### VILLAGE COVERED BRIDGE REHABILITATION - STP EH08 (6)

### BRIDGE STREET STORMWATER IMPROVEMENTS - SSMG 72

## PROPOSED IMPROVEMENT VILLAGE COVERED BRIDGE REHABILITATION AND BRIDGE STREET STORMWATER IMPROVEMENTS

**CONTRACT PLANS  
DECEMBER, 2014**

ROOF FRAMING PLAN

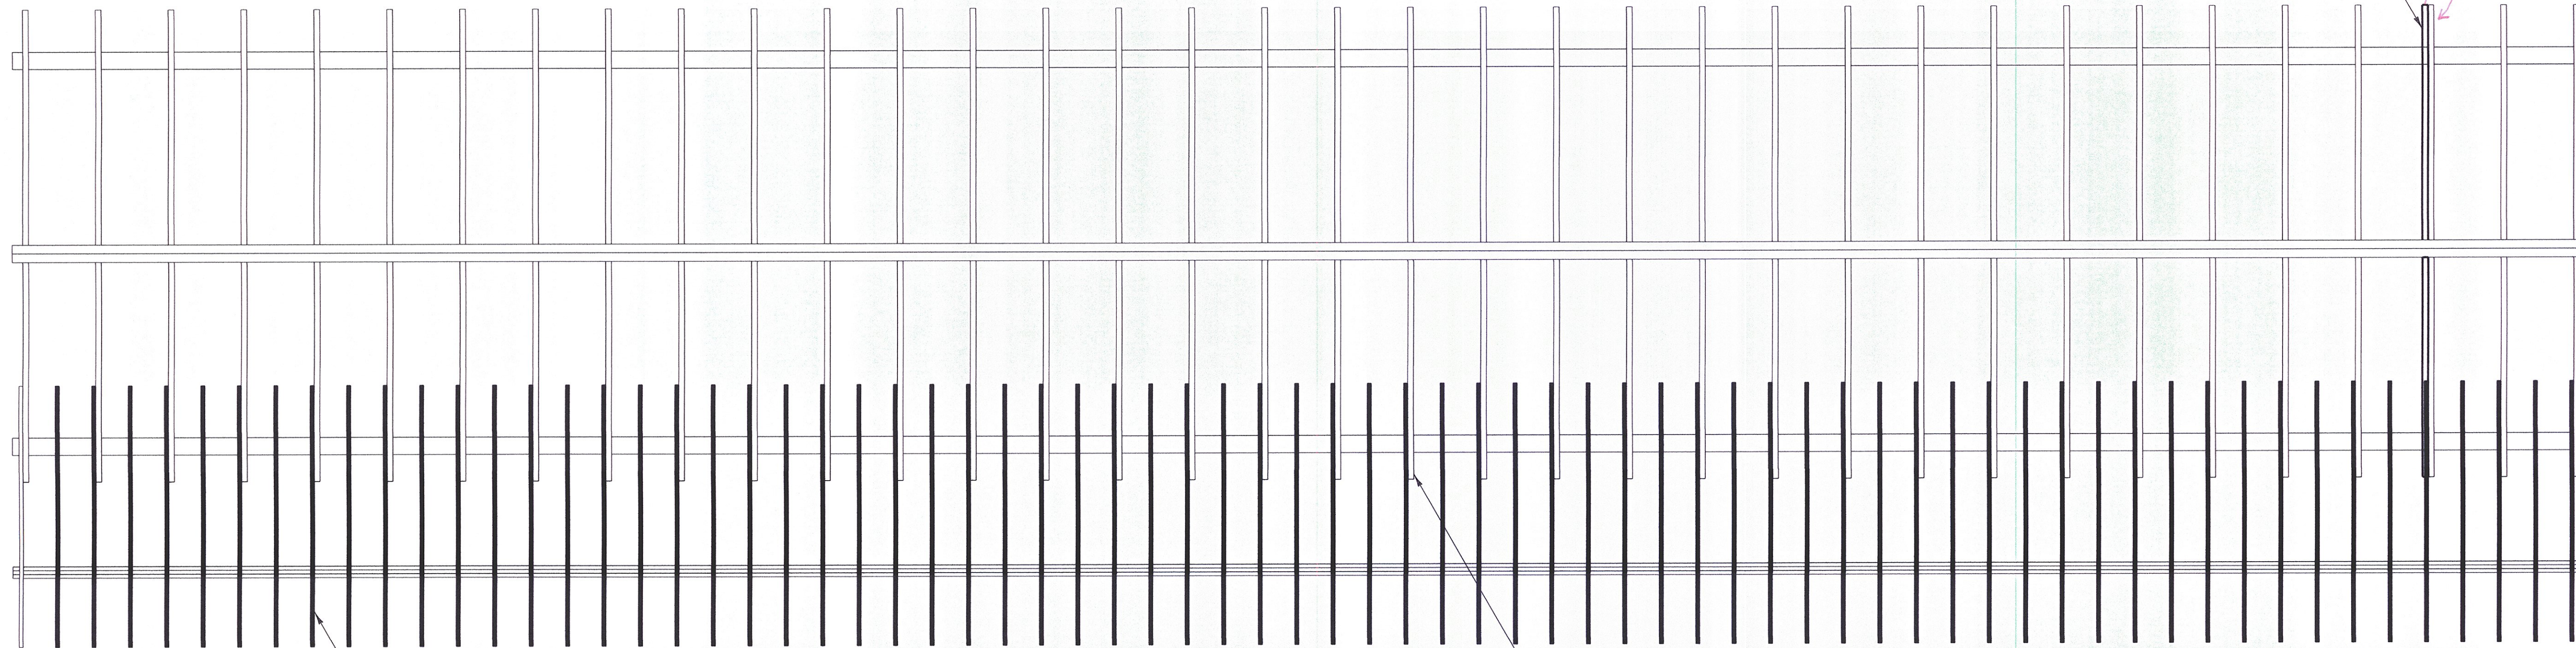
NEW 3" X 5" RAFTER  
MOVED  
TO  
OPPOSITE  
SIDE OF  
EXISTING  
RAFTER

FLOOR FRAMING PLAN

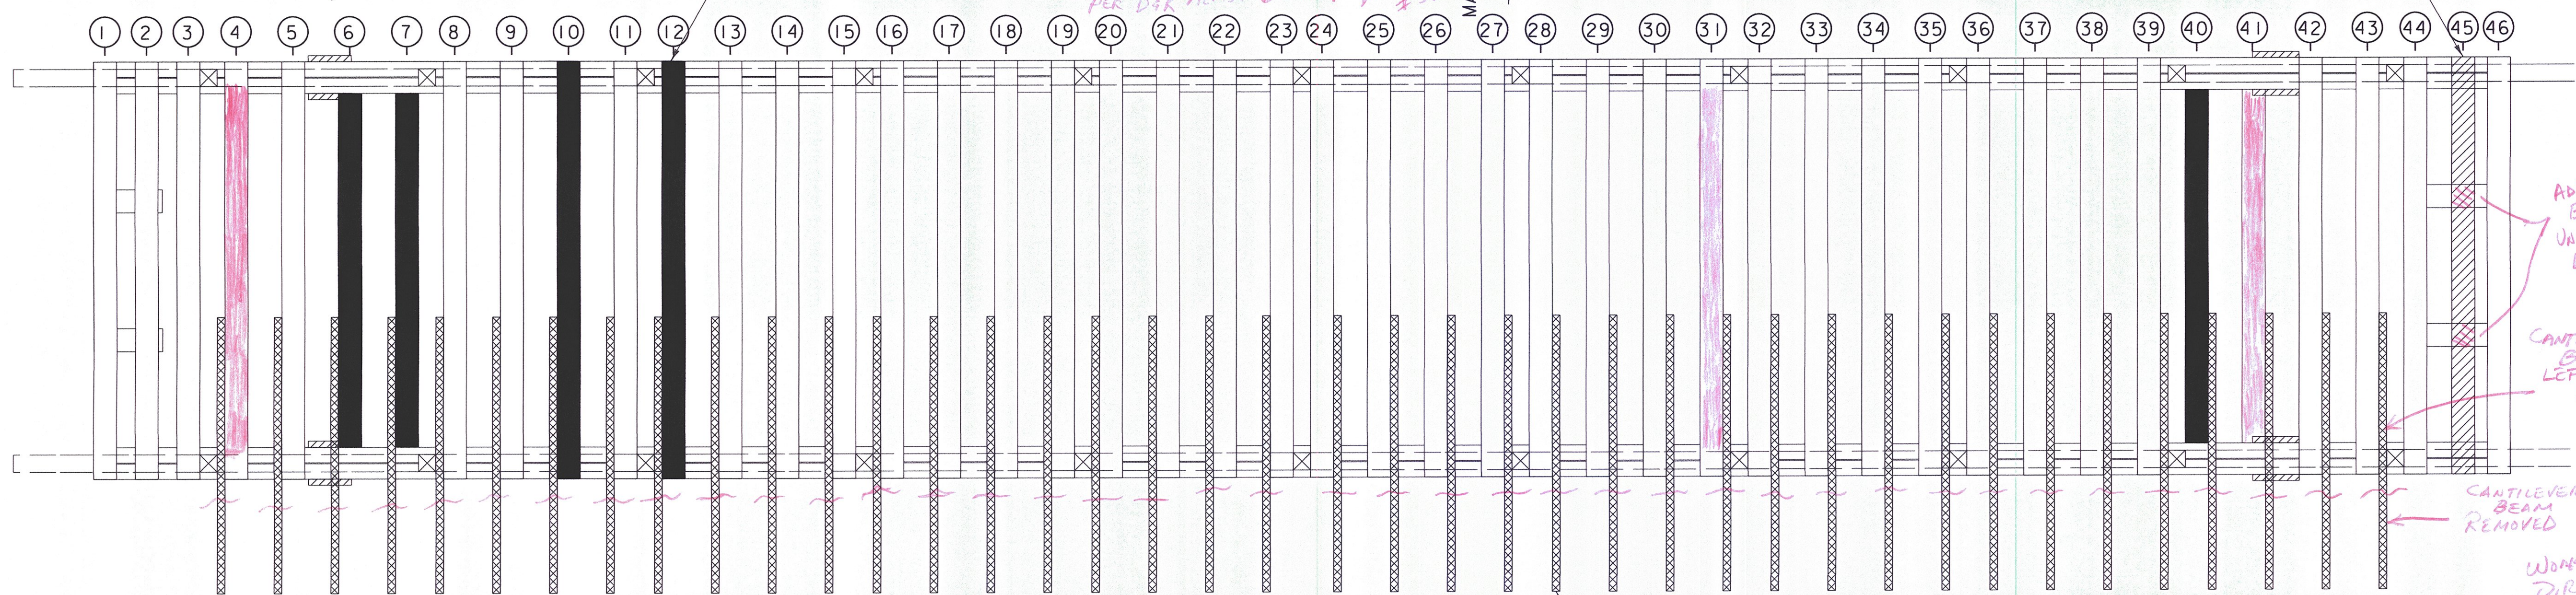
INCLUDING #4, 31, AND 41.  
REPLACED W/ DOUGLAS FIR  
PER D&K MEMO. 6-3-15. DIRECTIVE  
#3.

WORK  
DIRECTIVE  
#4  
6-8-15

NORTH ABUTMENT ELEVATION

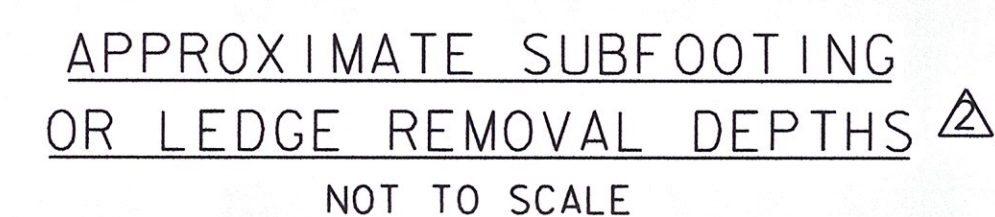
1. ELEVATION IS BASED ON A 2'-0" DEPTH OF SUPERSTRUCTURE AND BEARING FROM FINISHED GRADE TO BRIDGE SEAT. IF A DIFFERENT DEPTH OF SUPERSTRUCTURE AND BEARING IS USED, ADJUST THIS ELEVATION ACCORDINGLY, WHILE MAINTAINING A LOW CHORD NO LOWER THAN EL. ~~698.65~~ 697.94 NORTH BOTTOM

VOID UNDER ROCK  
FILLED WITH NON SHRINK  
GROUT IN LIEU OF  
CONCRETE.

NORTHEAST  
WINGWALL  
MASONRY AND  
REINFORCING

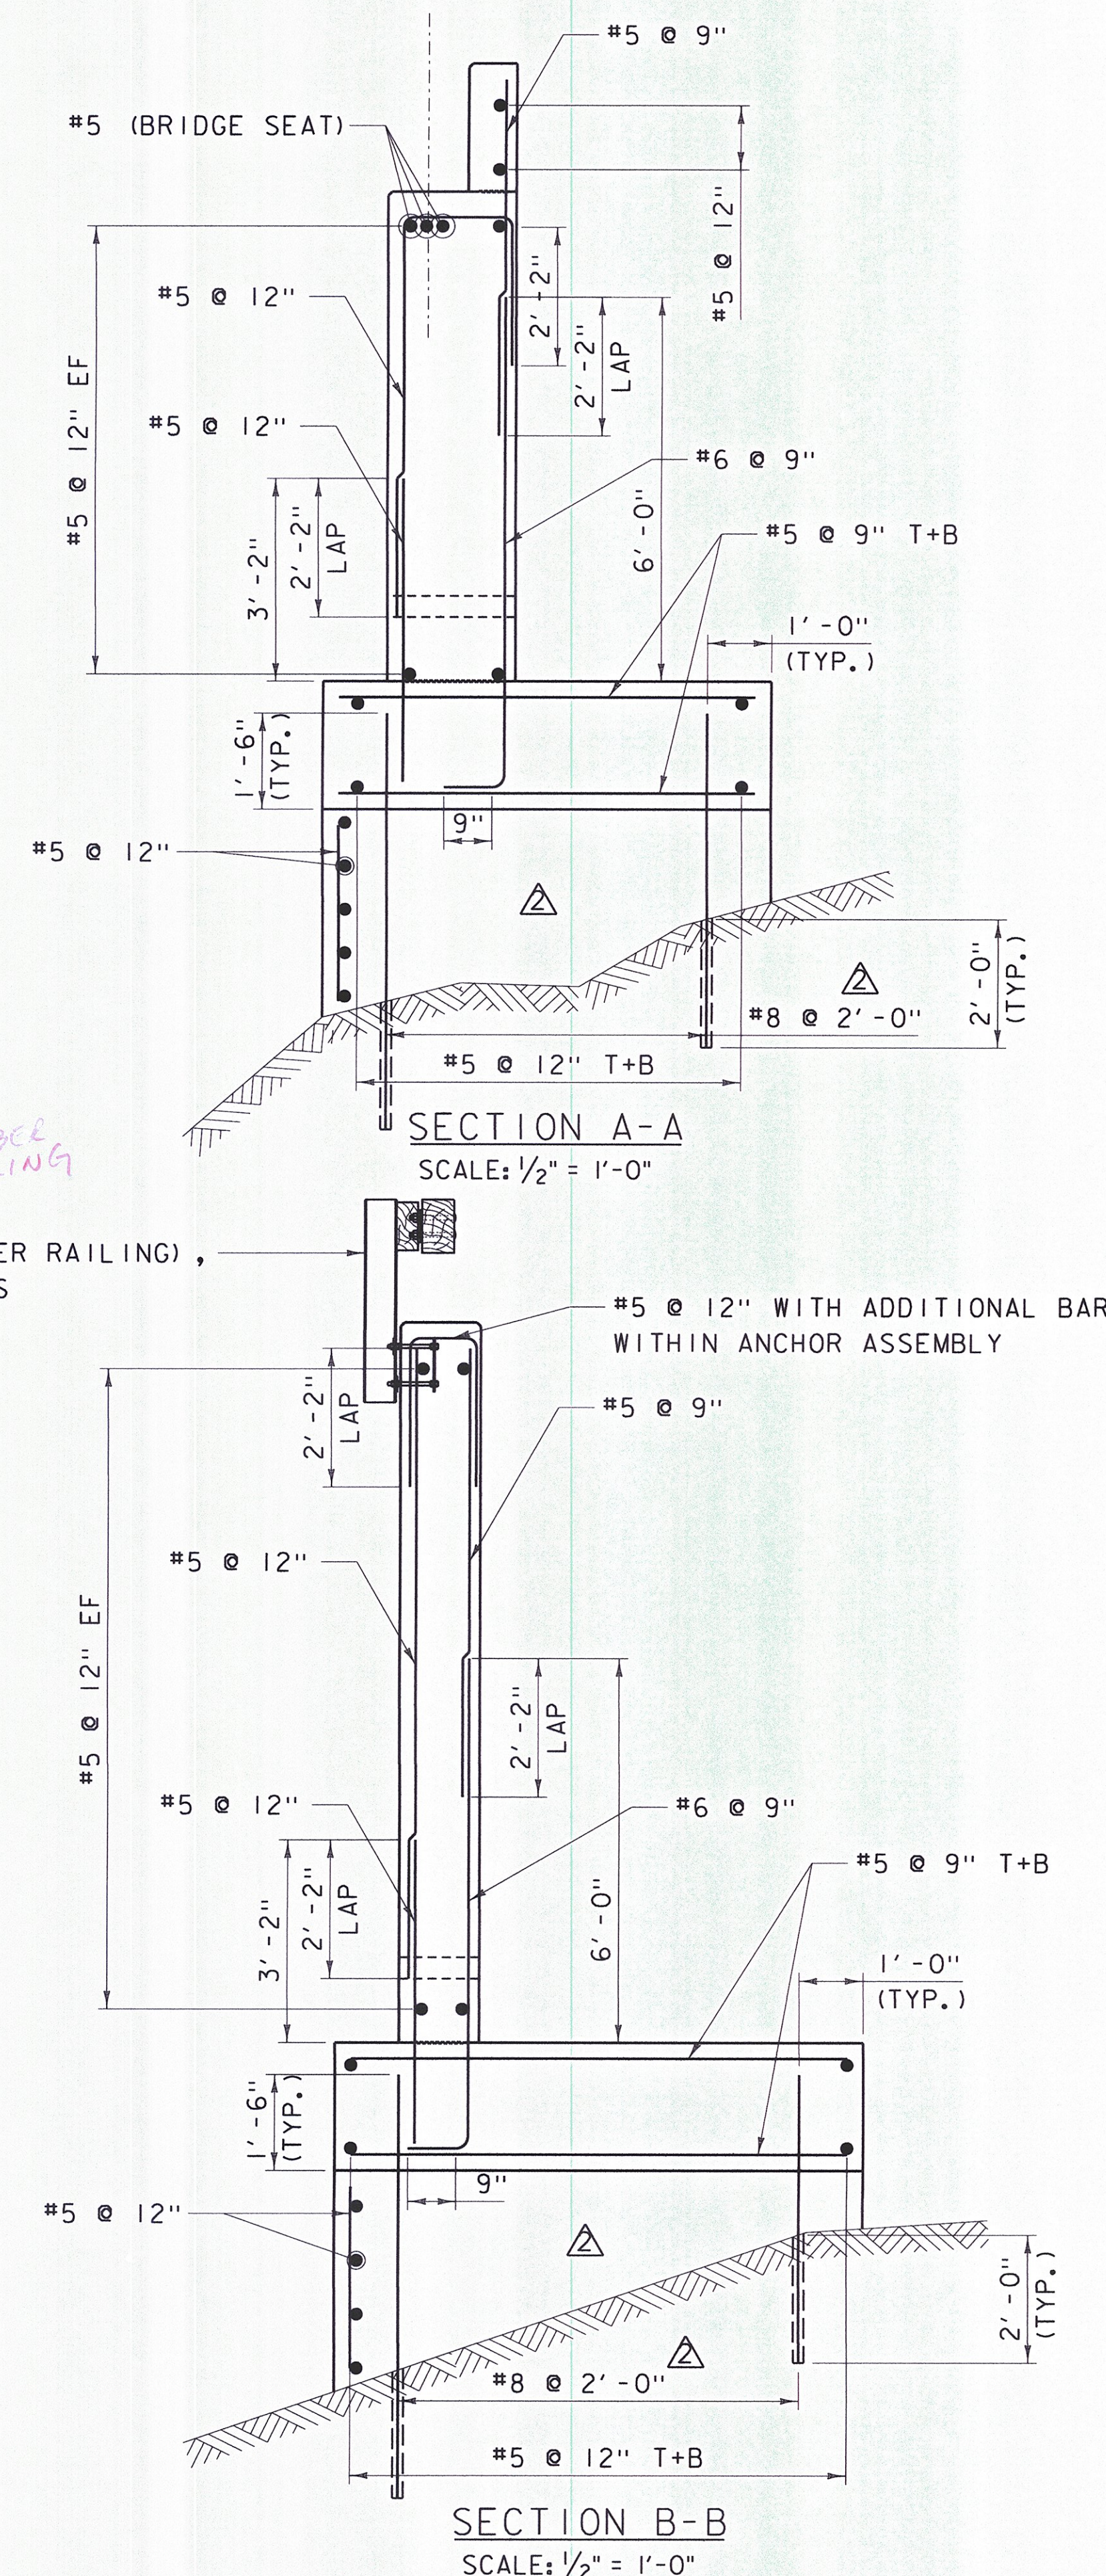
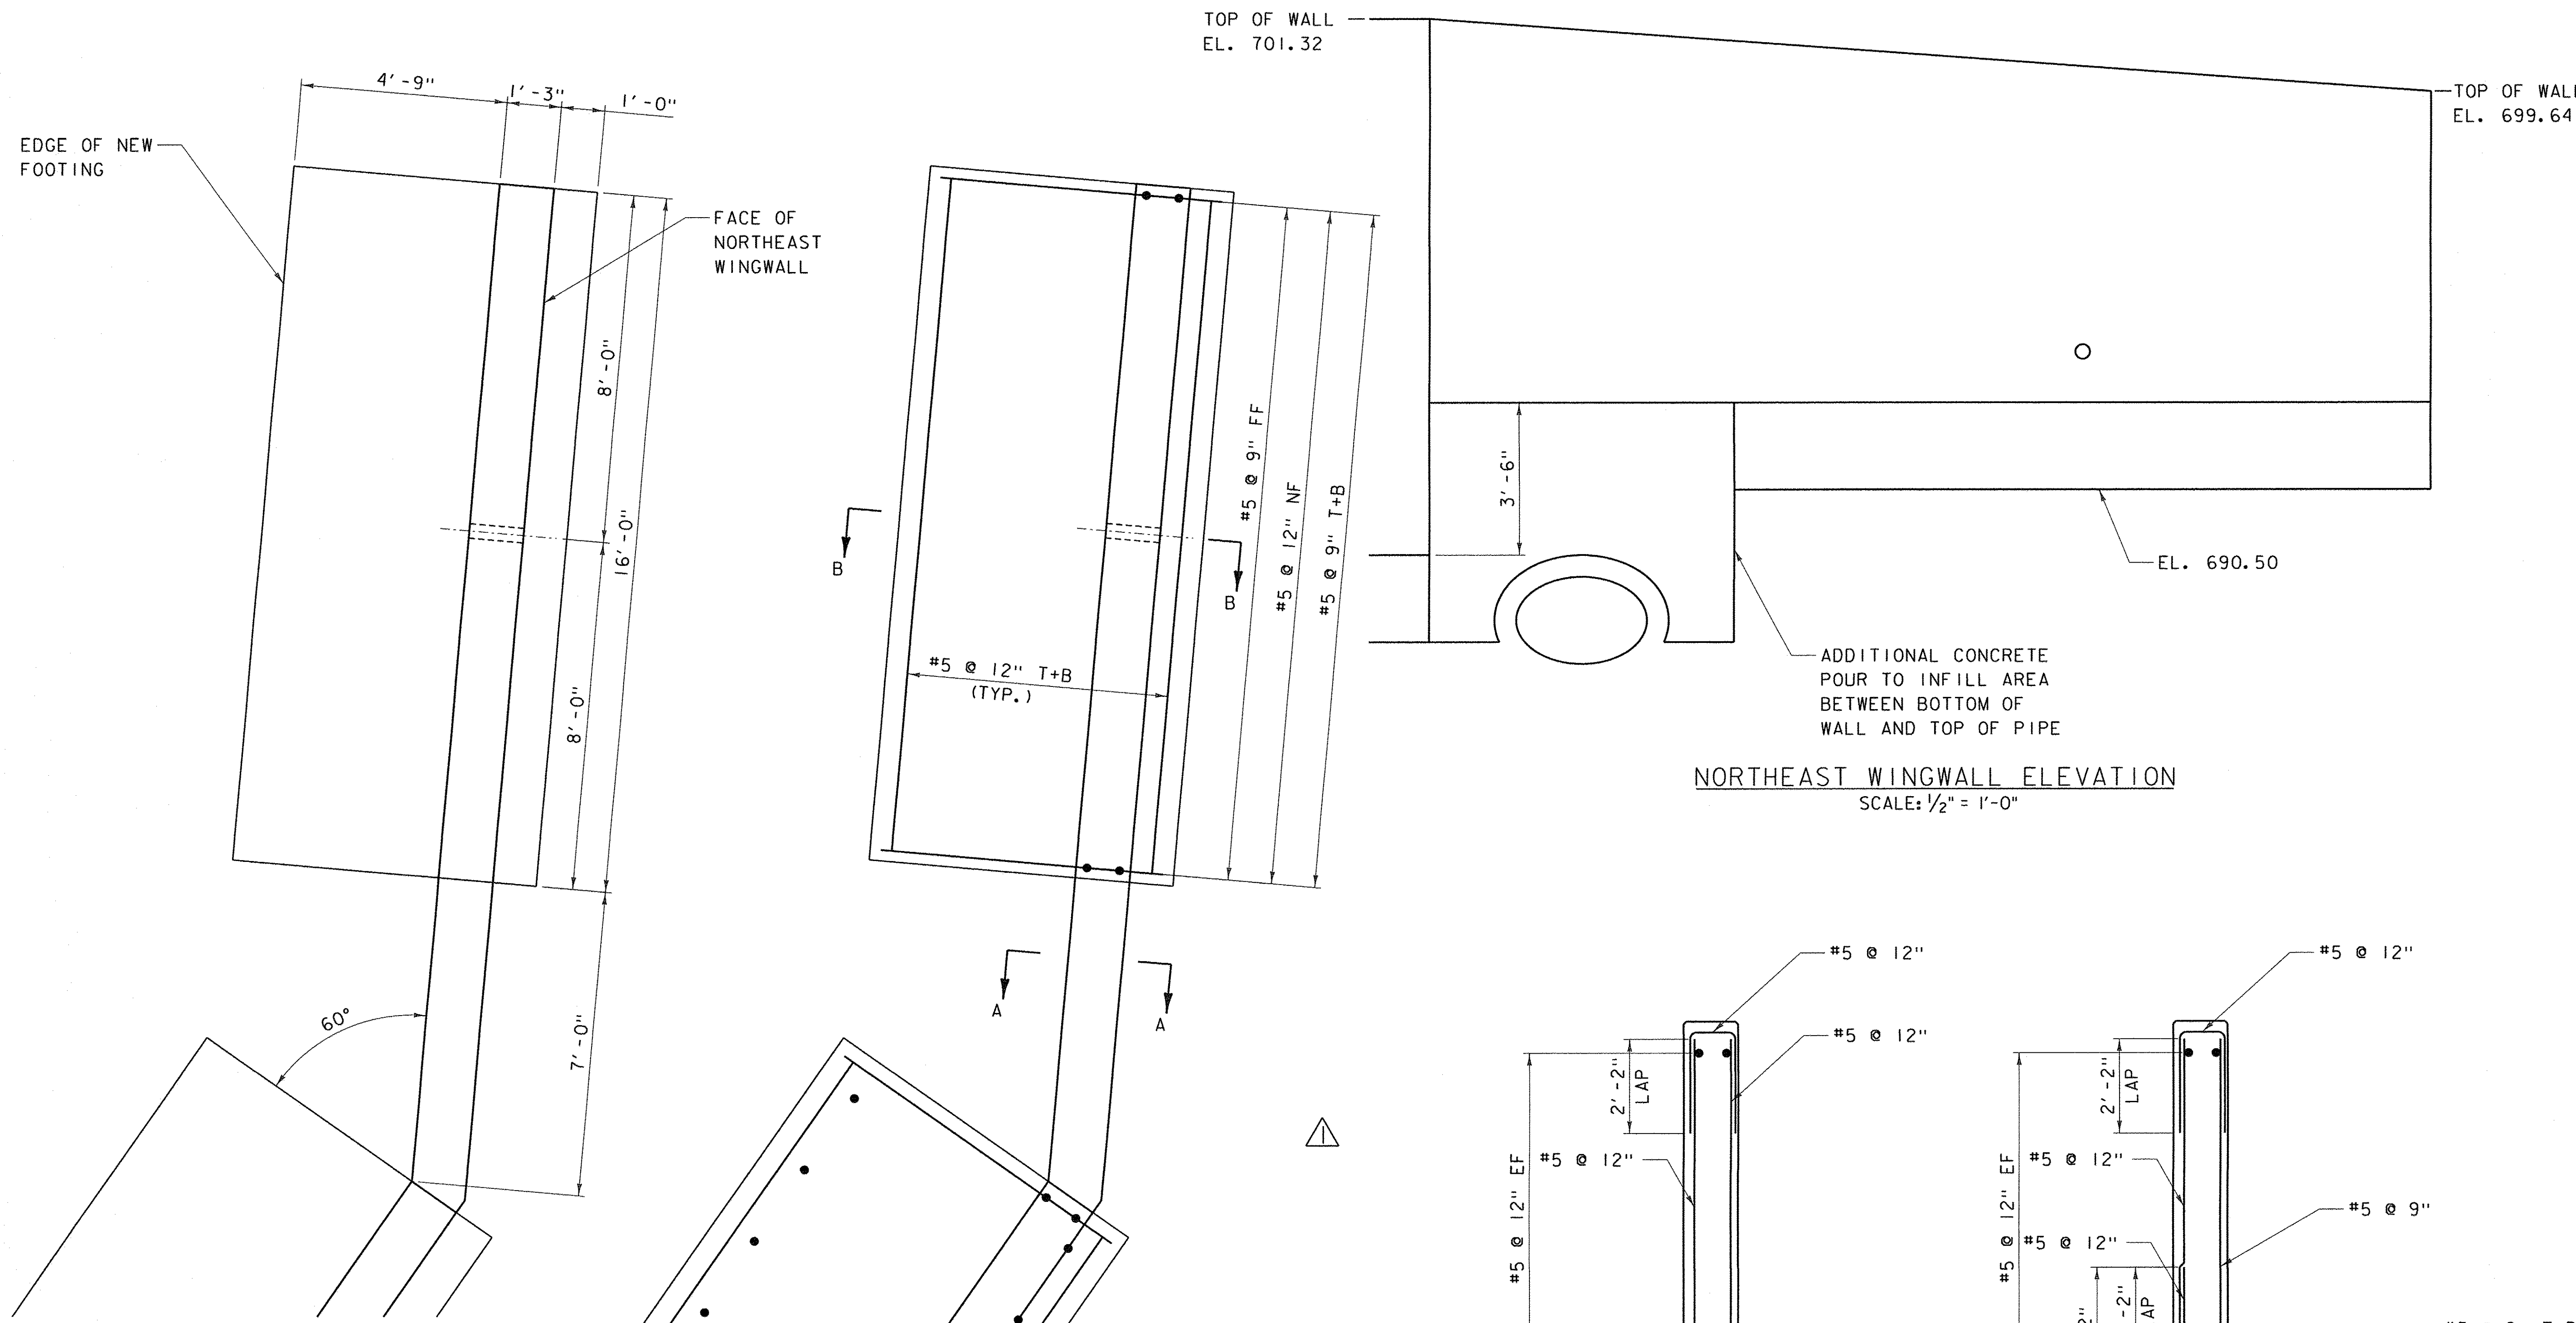
| NO. | DATE    | DESCRIPTION        | BY  | CHKD |
|-----|---------|--------------------|-----|------|
| 1   | 9/22/15 | NEW WALL AND SHEET | PCB | EPD  |
